Veterans Memorial Park

Maynard, MA

Preliminary Studies Report

CBA LANDSCAPE ARCHITECTS, LLC

Design Option 1 with existing Memorial and Performance Spaces in Red

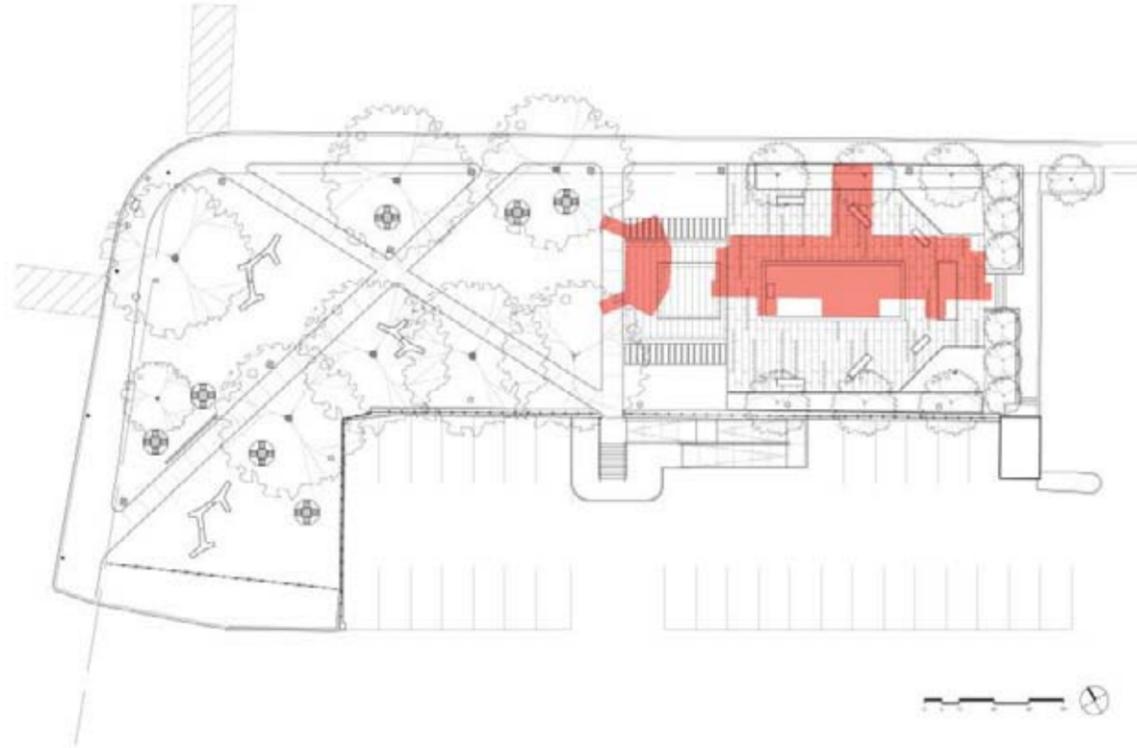
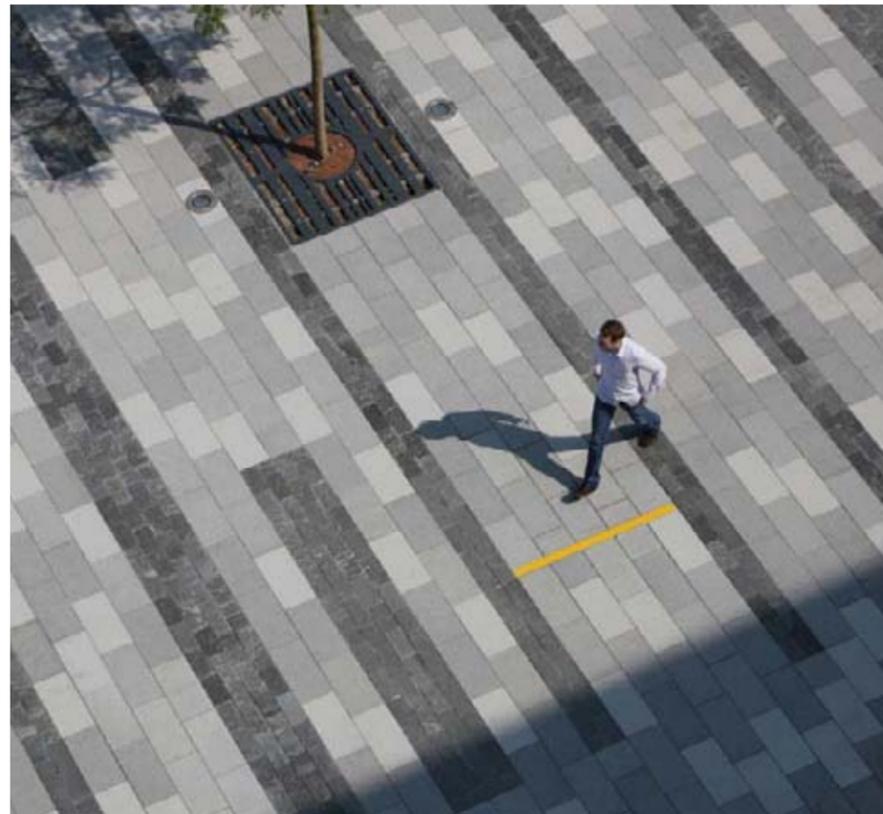
- The overall consensus was in favor of Option 1 - but with the performance area the shape of 2B.
- There was an overall consensus for lowering wall along the Nason Street Parcel.

- Performance stage shape doesn't seem to address both sides of the park; concerned that "wings" won't be utilized.
- A tiered stage, with the second level more in the middle?
- Likes how option 1 has the performance area stay where it is and a slight amphitheater lawn is formed.
- Take shape of stage from option 2b and locate it where the stage is located in option 1.
- Other performers include high school band.
- 2B stage shape is nice; could be 1/2 octagon; 35'x35' minimum for 45-55 people; (Option 3) Stage location will not work
- Stage design should work with multiple kinds of performances.
- Consider a flat/at-grade stage for maximum flexibility. This was seconded by other people.
- "Stage" should serve many activities i.e. dances, theater, rallies, etc.

Design Option 2b with existing Memorial and Performance Spaces in Red

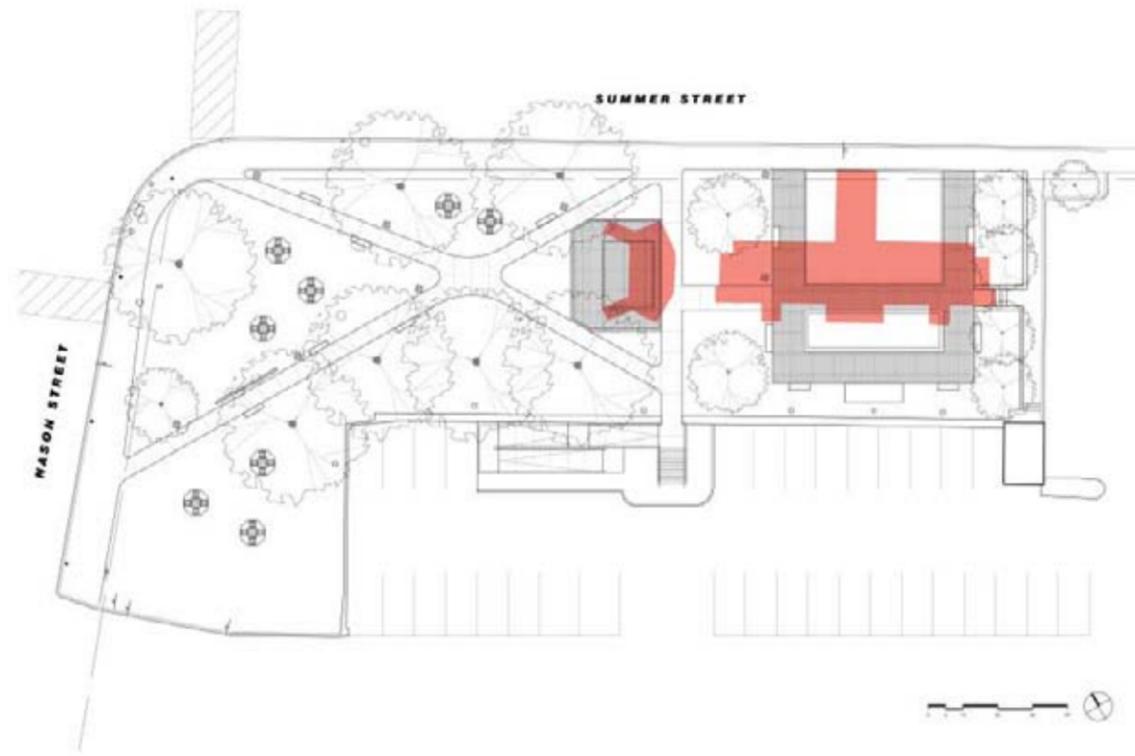
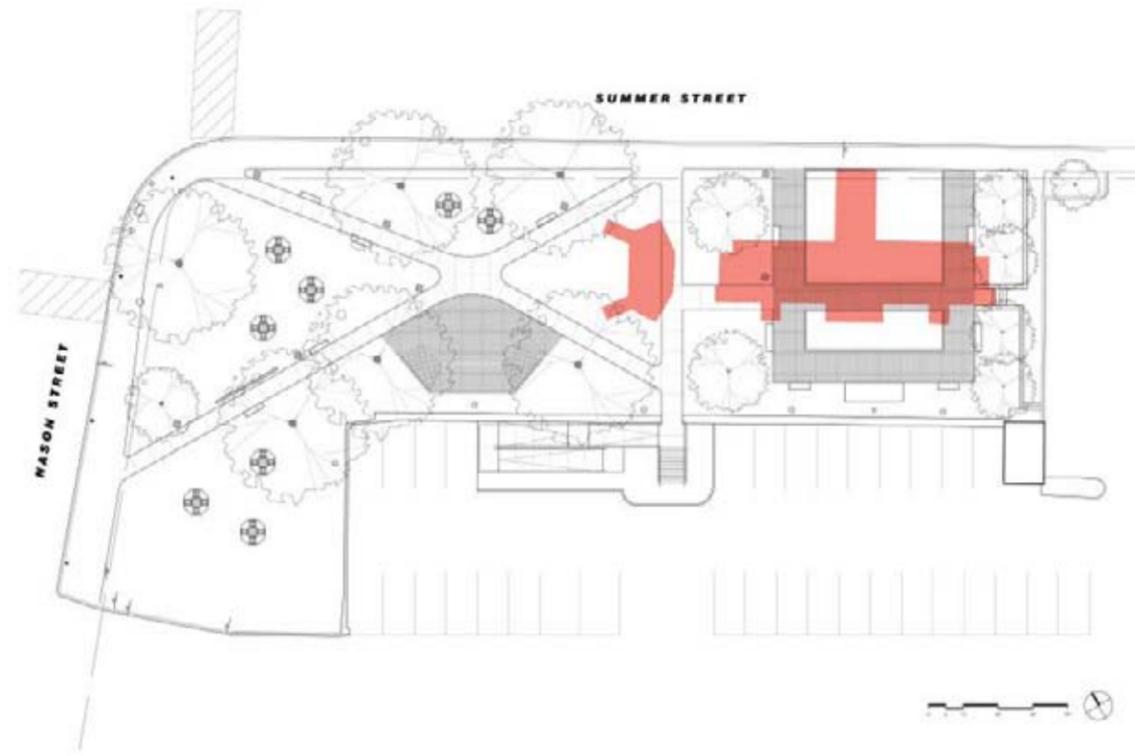
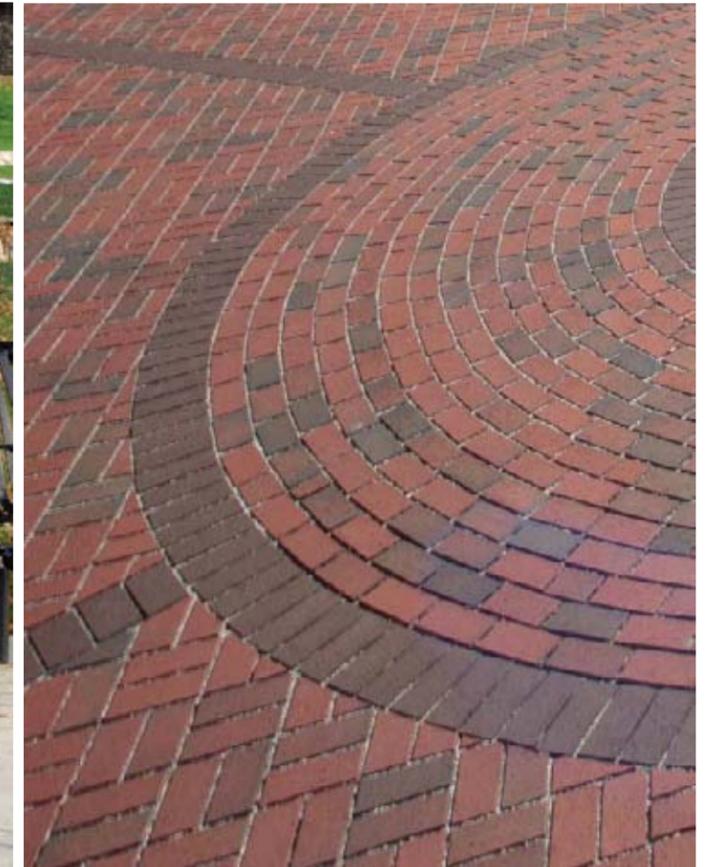
- (Diagram 2a/2b) having play in the Nason St parcel area seems unsafe for kids; too close to driveway of parking; (Clara – mentioned there is a fence there but agrees safety should be considered).

Plan, Sections & Elevations, Diagrams, Key Elements

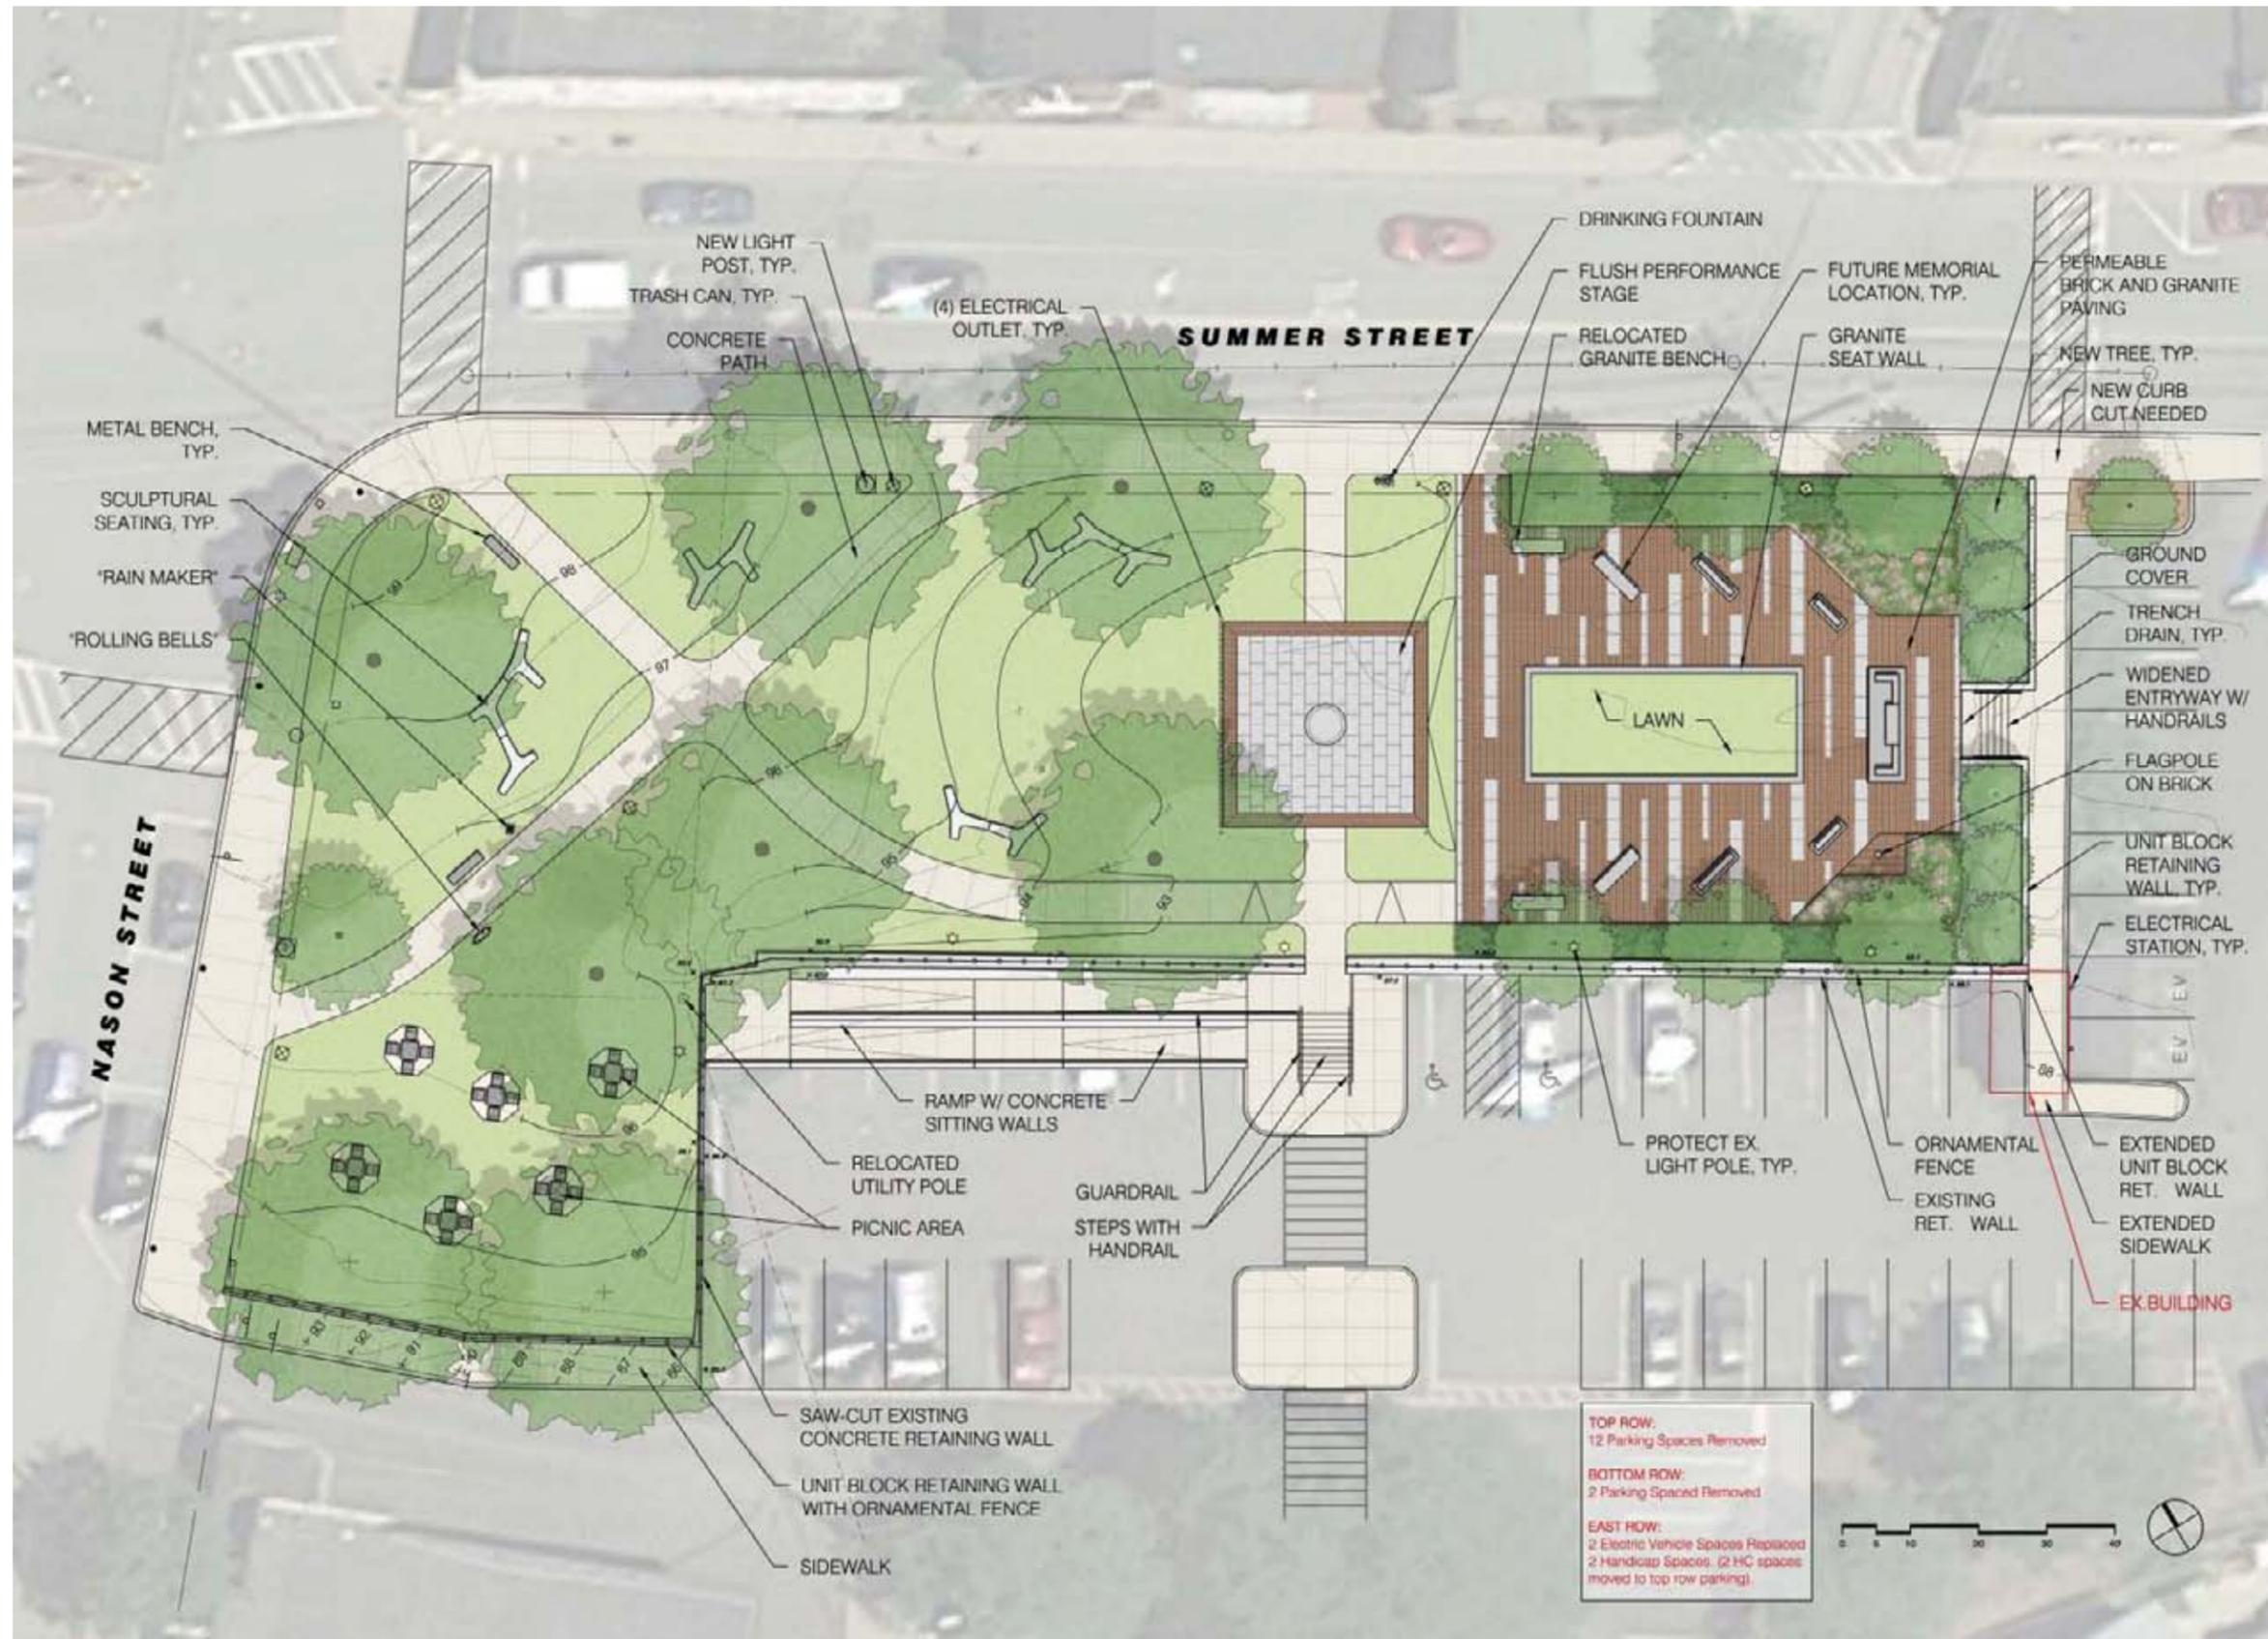
- Why make the performance area flush with ground?
 - (CBA) To create a space that’s more multi-purpose and accessible—an area that can easily transform between an active performance space/stage to a passive plaza area when no event is taking place.

- New “ramp” that takes away parking spaces may not be received well by the rest of the City
 - (CBA) - We will need to do a more thorough study of the parking area and how we can reconfigure it to minimize parking loss while maximizing connectivity between the park and the rest of the Town.

- How many trees will be lost in this design?
 - (CBA) Several of the large trees and most of the smaller trees in the memorial area are removed to allow for better circulation throughout the park; New trees have been added to the memorial area in the new design.

- Why have a path cut straight through the performance space? Why not off to the side/in front/behind space?
 - (CBA) When a performance will take place, people are more likely to take the paths around the space. When there is no performance, the path will provide pedestrians with a direct way through the park. (In an earlier plan, there was a path immediately in front of the performance space, but this appeared to cut off this area and the memorial from the rest of the park. By pulling the performance space slightly away from the memorial area, the two areas are more clearly defined programmatically.)

- Where did the 35’x35’ dimensions come from for the performance space?
 - (CBA) They were based off of the Community Band’s suggestions (Note/CBA correction: current dimensions are 30’x30’ which is within the size range initially suggested by band leader)

- Has the topography changed? How will drainage work? How does drainage currently work?
 - (CBA) The design subtly manipulates the existing gradual slope down into the park to create a more concave-sloping, defined lawn area for people to gather in front of performances. We have proposed areas to place trench drains to capture the water that will run down the hill. Currently, it appears that water simply soaks through the ground. We will need a Civil Engineer to investigate the site more carefully as we push the design further.

- How will a lawn mower access panel of grass surrounded by sitting wall in memorial area?
 - (CBA) A part of the wall can be cut with a slight ramp to allow lawn mower to be rolled up.

ORNAMENTAL FENCE STUDIES FOR TOP OF RETAINING WALL

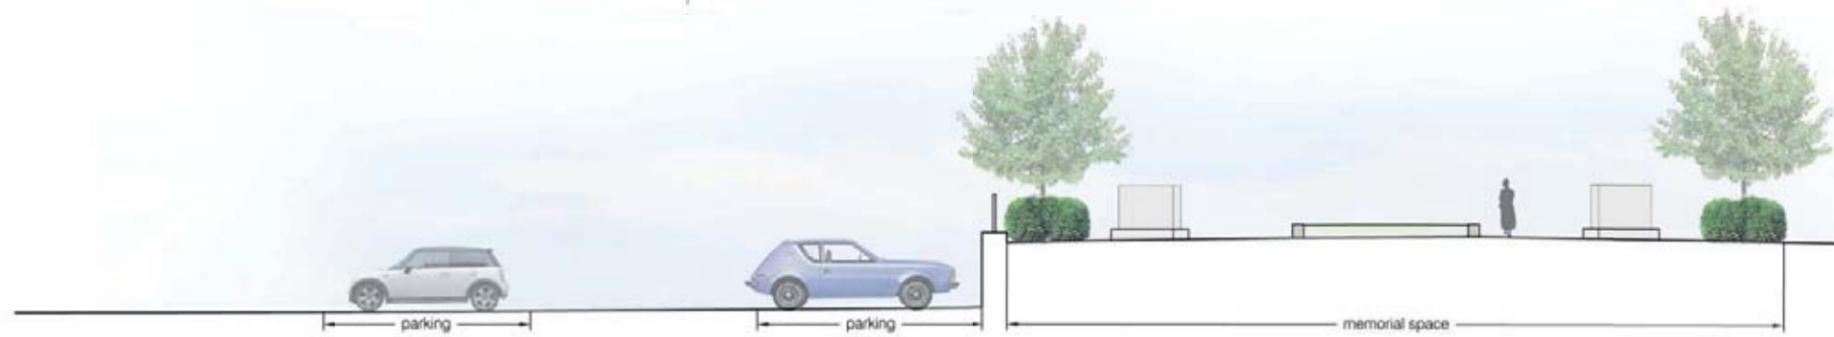
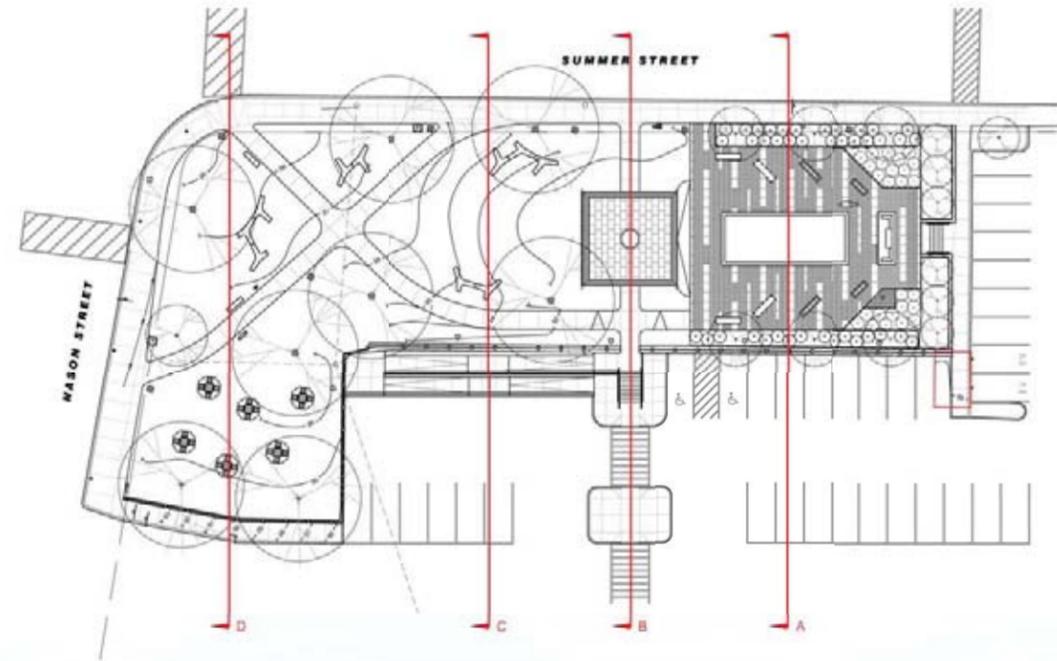
- Add planting that's low-maintenance but colorful and has seasonal like potentilla or easy-care roses.
- Musical fence will be too distracting during performances and conflicts with overall atmosphere of solemnity of the memorial park. As there ways to mute/muffle the sound as needed?

- Others felt that musical fence adds a nice playful element to the park; if not the musical fence, any quieter objects?
- Use brick material – works better with overall Town feel and refers back to Mill history/materiality.
